RENESAS TECHNICAL UPDATE

| Product Category | MPU/MCU | | Document No. | TN-RX*-091A/E | Rev. | 1.00 |
| Title | Corrections to the RX111 Group User's Manual: Hardware regarding Communication Protocol of the Flash Memory | | Information Category | Technical Notification | | |

Figure 35.13 Data Format for Bit Rate Automatic Adjustment is corrected as follows:

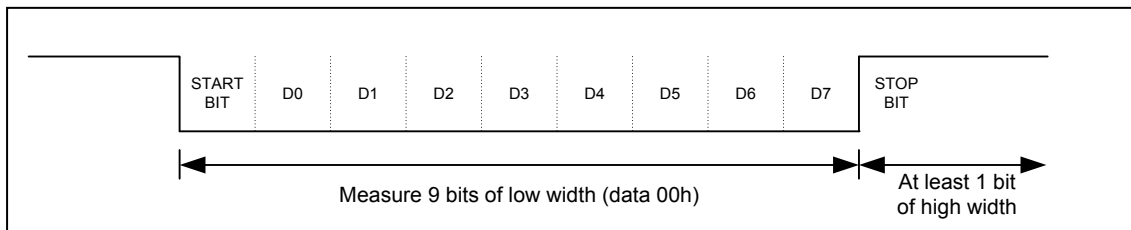
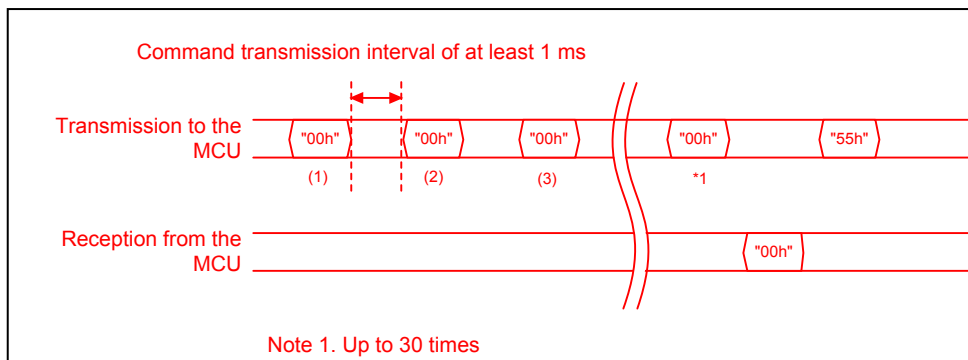
Before correction

After correction

Figure 35.16 Procedure to Select the Device and Change the Bit Rate is corrected as follows:

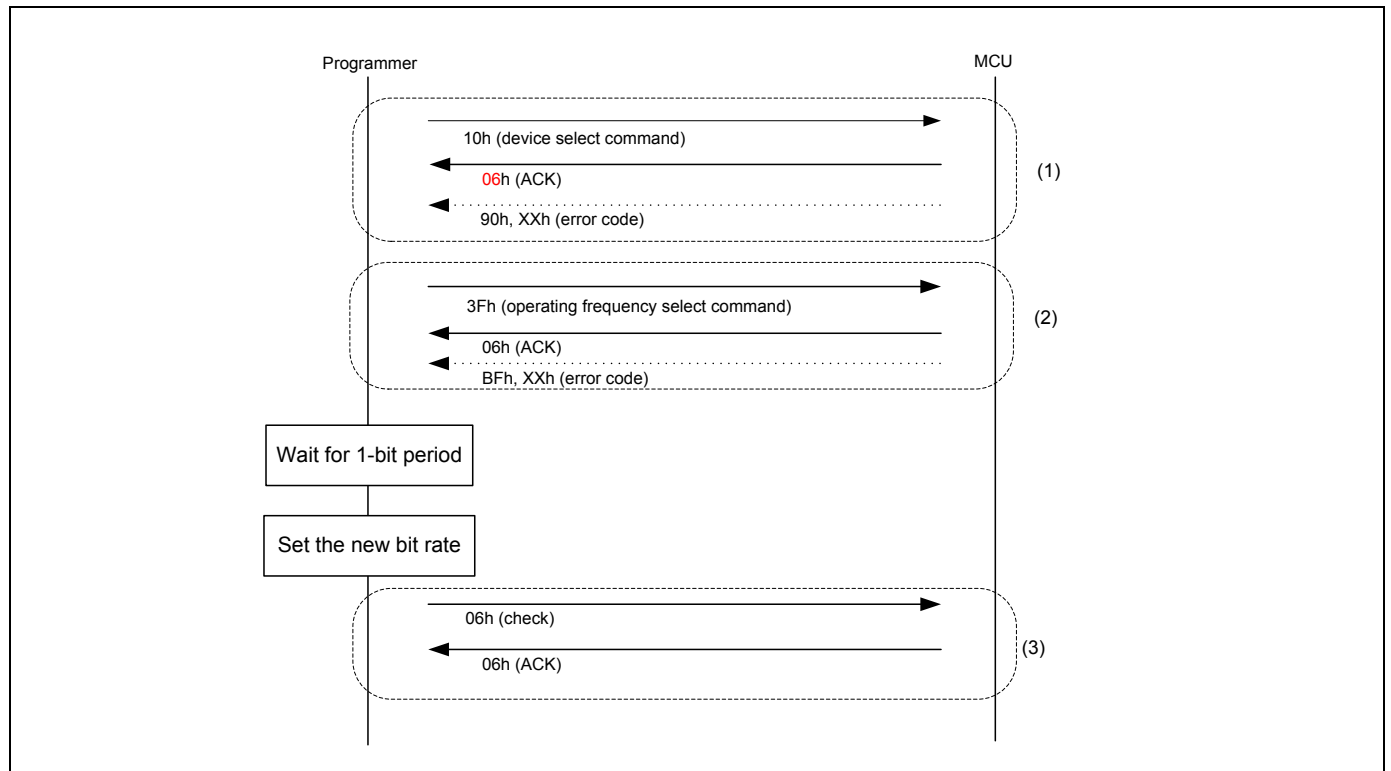
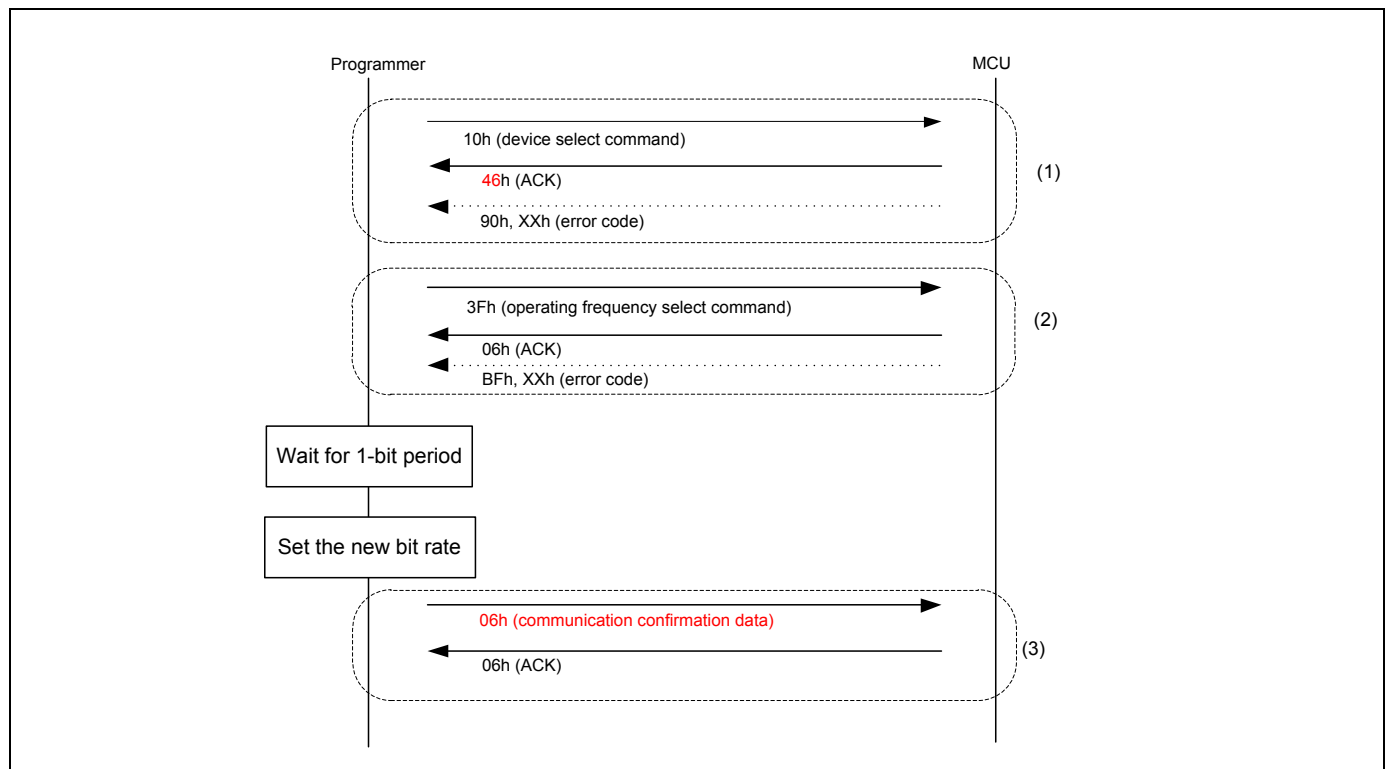
Descriptions in 35.9.10.3, Procedure to Select the Device and Change the Bit Rate are corrected as follows:

- (3) When **the MCU** receives a response (06h), the MCU waits for 1-bit period at the bit rate for sending the operating frequency select command, and then set the bit rate of the programmer to the changed value. After that, the MCU sends communication confirmation data (06h) at the changed bit rate. When the MCU receives the command successfully, the MCU sends a response (06h) of the communication confirmation data.

- (3) When **the programmer** receives a response (06h), the MCU waits for 1-bit period at the bit rate for sending the operating frequency select command, and then set the bit rate of the programmer to the changed value. After that, the MCU sends communication confirmation data (06h) at the changed bit rate. When the MCU receives the command successfully, the MCU sends a response (06h) of the communication confirmation data.

Figure 35.19 Procedure to Send Commands in Erase Ready Operation is corrected as follows:

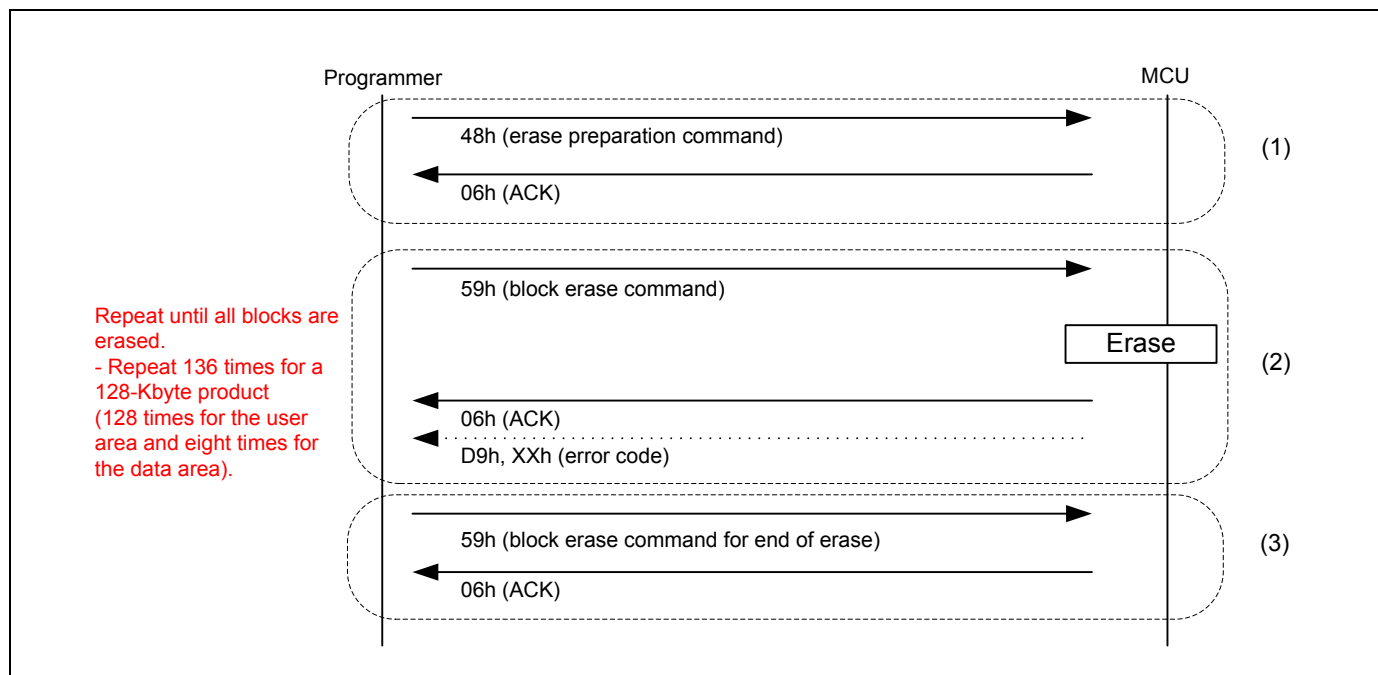
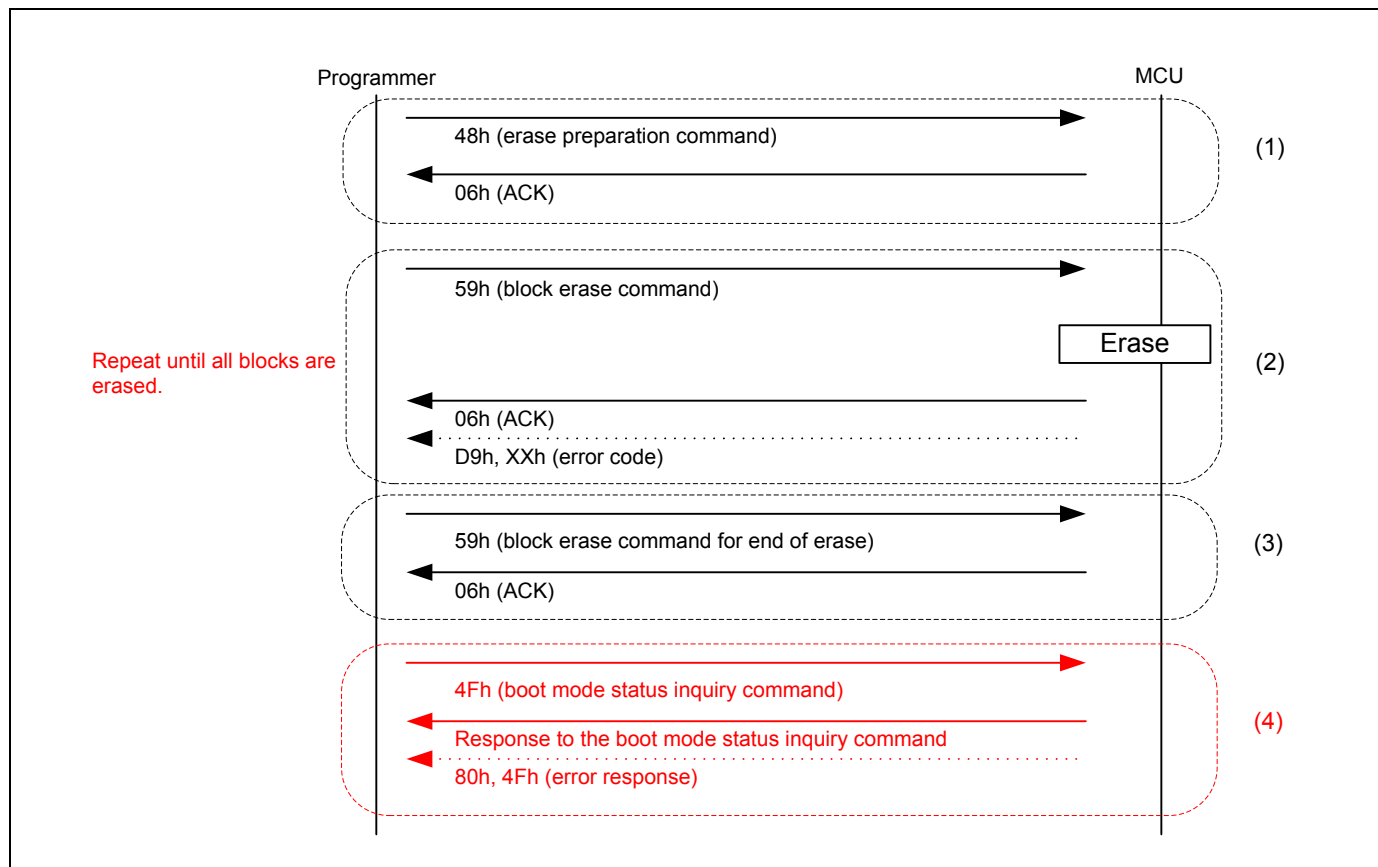
Descriptions in 35.9.10.6, Erase Ready Operation are corrected as follows:

Send a block erase command repeatedly until block erase commands for all blocks are sent. When the operation ends before all the block erase commands are sent, a command error may occur even when a correct command is sent in the program/erase state.

Send block erase commands repeatedly until a block erase command has been sent for the total number of blocks. The total number of blocks is the sum of the user area blocks and data area blocks that are obtained in advance using the block information inquiry command. If the operation ends before all the block erase commands are sent, a command error may occur even when a correct command is sent in the program/erase state.

(3) Send a block erase command for end of erase (59h 04h FFh FFh FFh FFh A7h). The MCU sends a response (06h).

(4) To confirm whether erase ready operation has ended, send a boot mode status inquiry command (4Fh). When the erase ready operation has ended, the MCU returns the result of the boot mode status inquiry. When the erase ready operation has not ended, the MCU sends an error response (80h 4Fh). When an error response is received, restart the MCU in boot mode and perform the procedure again from section 35.9.10.1, Bit Rate Automatic Adjustment Procedure.
